■RA61F MANUAL TRANSMISSION

1. General

276PD06

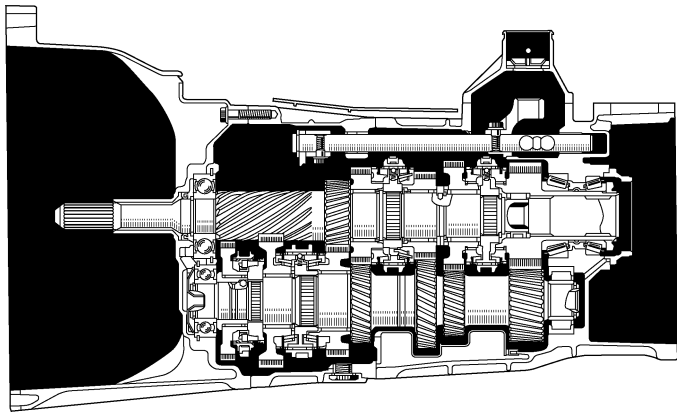
On the new Land Cruiser/ Land Cruiser Prado equipped with the 1GR-FE or 1KD-FTV engines, a newly developed, RA61F 6-speed manual transmission has been newly adopted.
